RE: UGA PRELIMINARY DECLARATION CASE NO. UGA17-06, 6719 DEVON AVE.

We are writing to express our concerns for the adequacy of the public facilities available to serve the development proposed in UGA Case 17-06, for property at 6719 Devon Avenue SE. Our properties are located at 928 Elkins Way / 6700 Devon Ave. / 6995 Devon Ave., which are directly across Devon Avenue from the proposed development. Devon Avenue is the access to our property, and the volume of traffic resulting from this 86-lot development will adversely affect the safety of travel on this street as well as on Rees Hill Road, which is the intersecting street to the south. As a result, it will have an adverse effect on our property.

Attachment 1

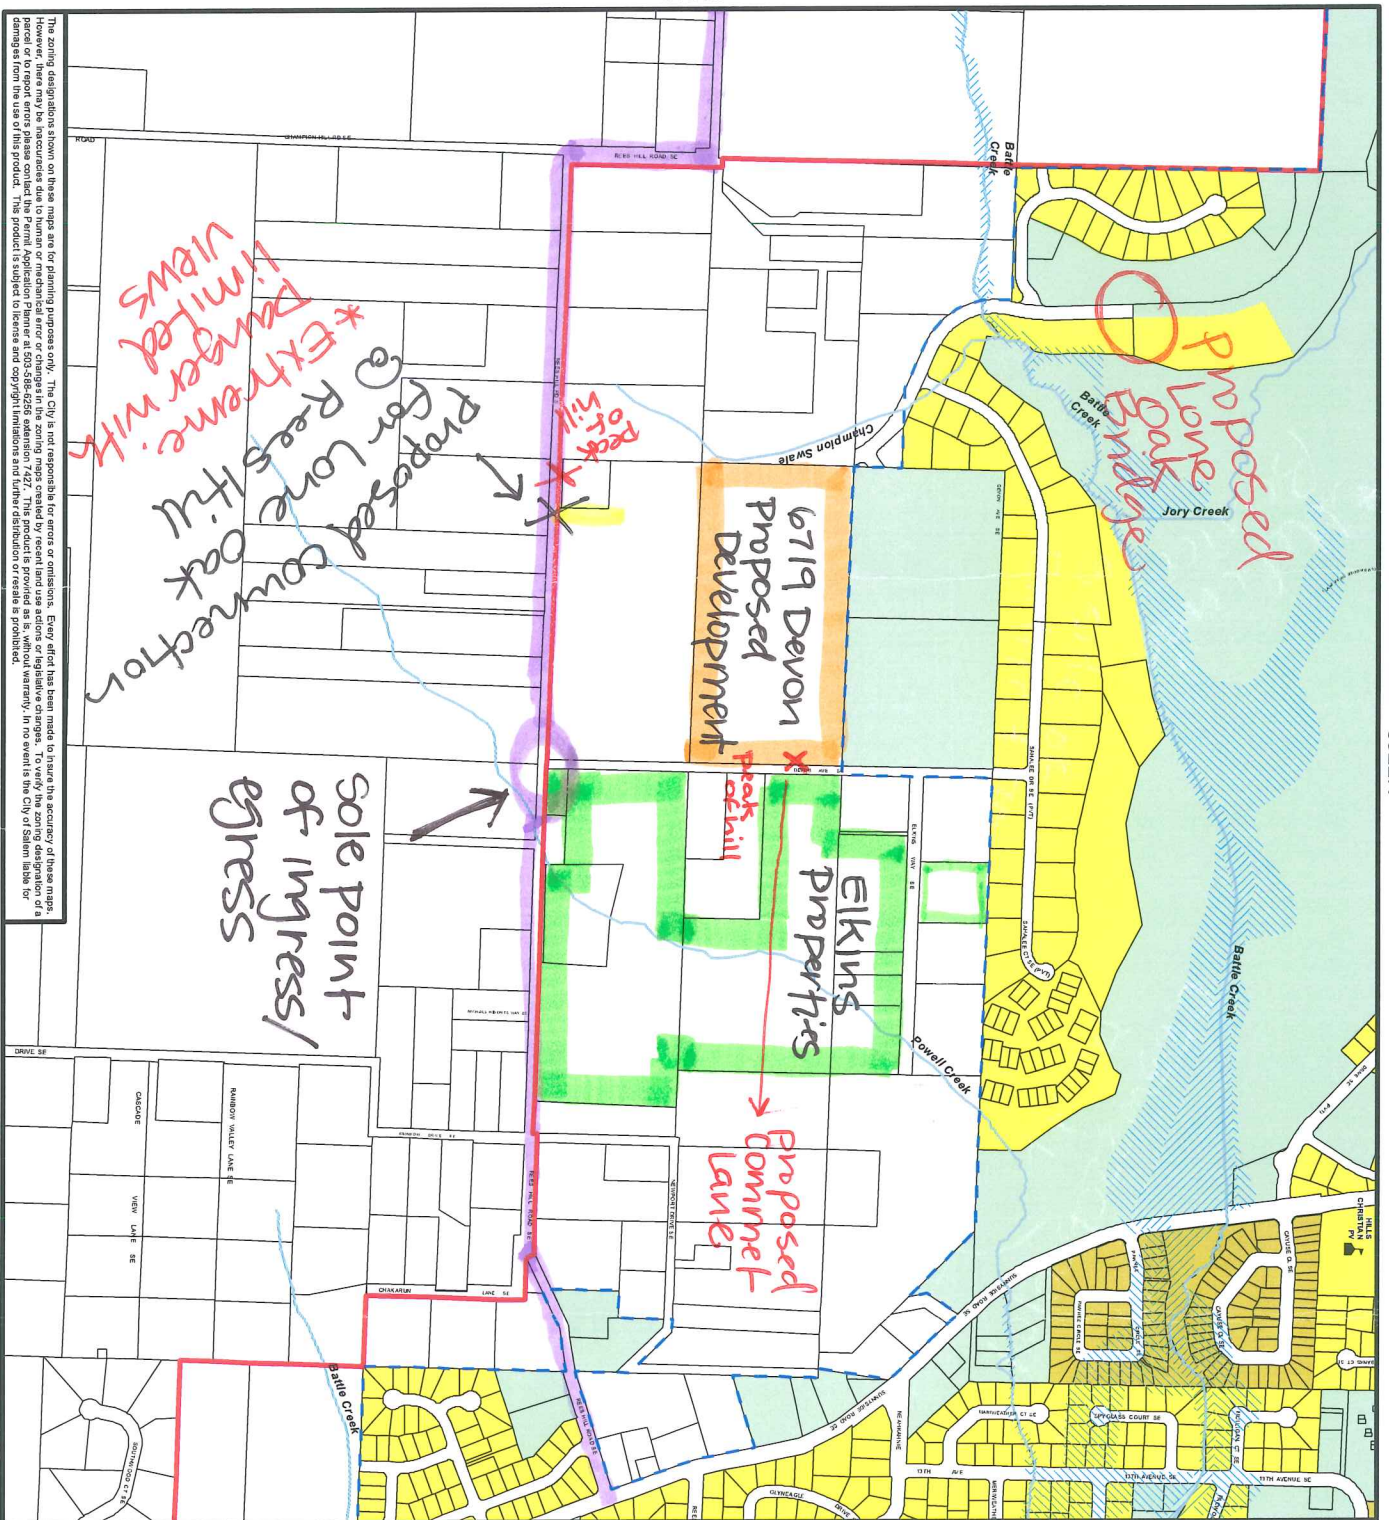
The influx of this many single-family dwellings will increase traffic beyond the reasonable capacity of existing county roads. First, the single route of ingress/egress is the intersection of Devon Ave and Rees Hill Rd. Additionally, the sole route to main arteries of travel is via Rees Hill Rd. Rees Hill Road is one of two weight restricted roads in Marion County. The section of Rees Hill West of Devon has a weight limit due to the fact that it is a slurry sealed road, not actually paved. The road is in complete disrepair with the current volume of traffic. Adding traffic from 86 additional residences to the flow of traffic would be very detrimental to the quality of the road surface causing further deterioration and greater safety hazard for motor vehicles, bicycles and pedestrians.

Another concern is the proposed intersection of Commet Lane with Devon Ave on the Eastern end of the development. This will intersect Devon Ave. on the north side of the hilltop and would have restricted sight distance when pulling out to travel North on Devon Ave. This creates an extreme traffic hazard. Additional access to the North and West sides of proposed development is not possible without further annexation of multiple properties West, and development of noted properties (083W22DB00900, 083W22CB00100, 083W22CB00104, 083W22CB00105).

Attachment 2

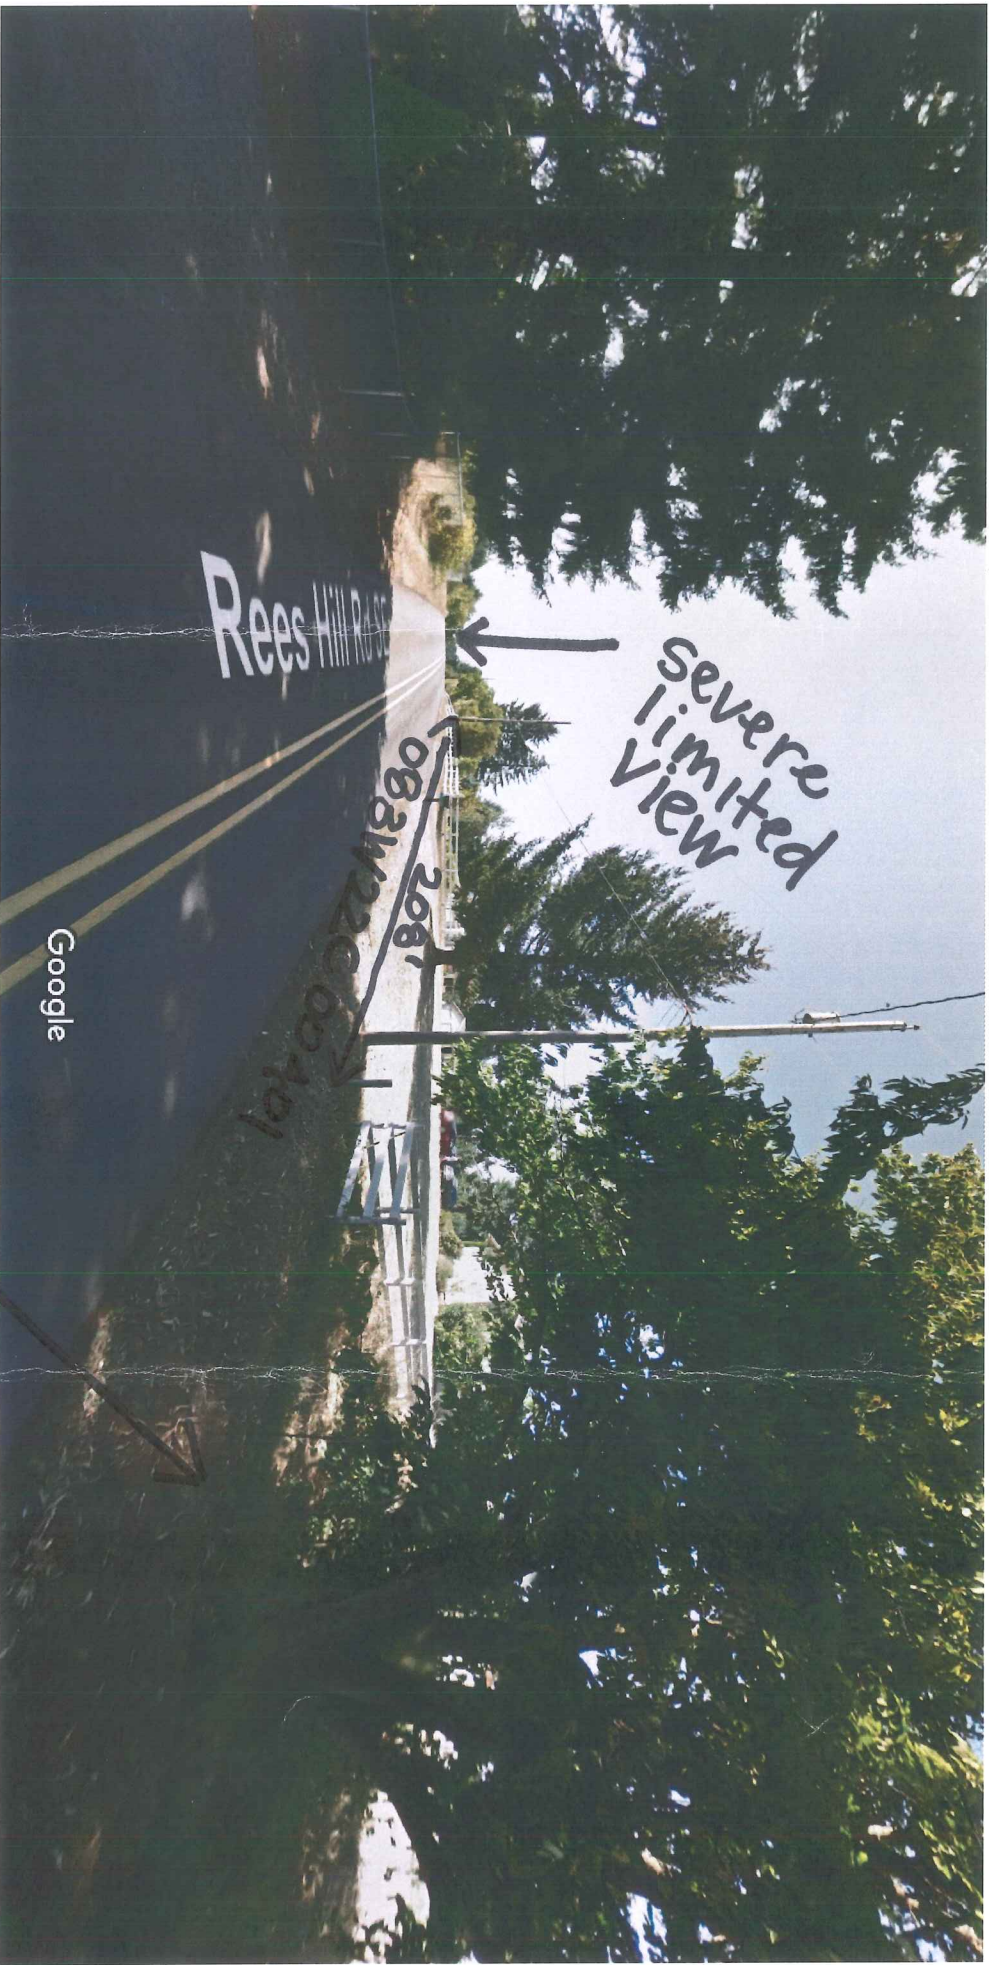
Traveling West on Rees Hill. Proposed intersection with Lone Oak to the right where the tree is located.

Marion County
Driveway Access Construction Standards
Minimum sight distance
400 feet @ 45 mph

Attachment 3

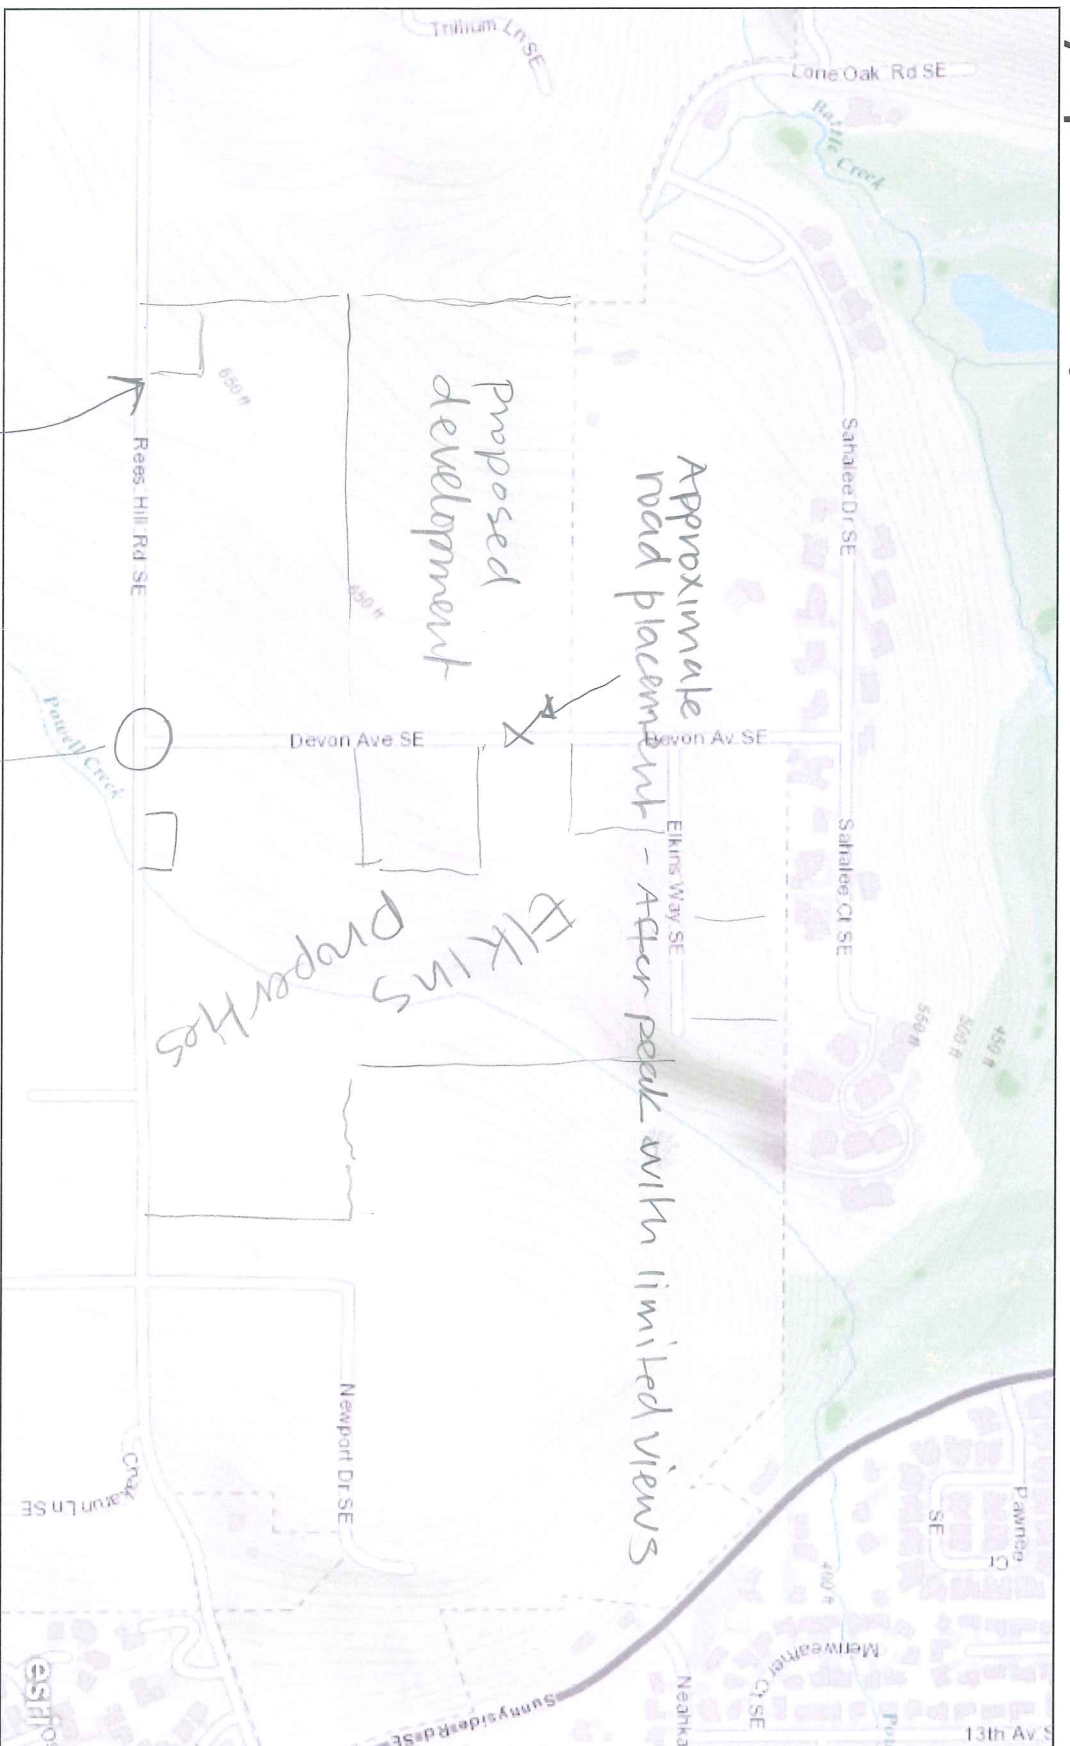
Lastly, several acres of the proposed development are sloped toward our properties. Storm water runoff is a concern. Since the improvement and paving of Devon Ave, our property already experiences a significant increase of runoff that is draining directly onto our property and causing erosion. This erosion is impacting and limiting our options for farm use. There is currently no good gravity fed solution. It would flow downhill, through our properties or on the opposite side of the development directly into Powell Creek or Battle Creek. Will this be handled with on-site detention and treatment, such as a bioswale? How will the storm water be collected, handled and where will it be discharged?

Proposed point of connection

Single point of entry

Lone Oak onto Rees Hill

Note: Extreme limited view after peak of Hill
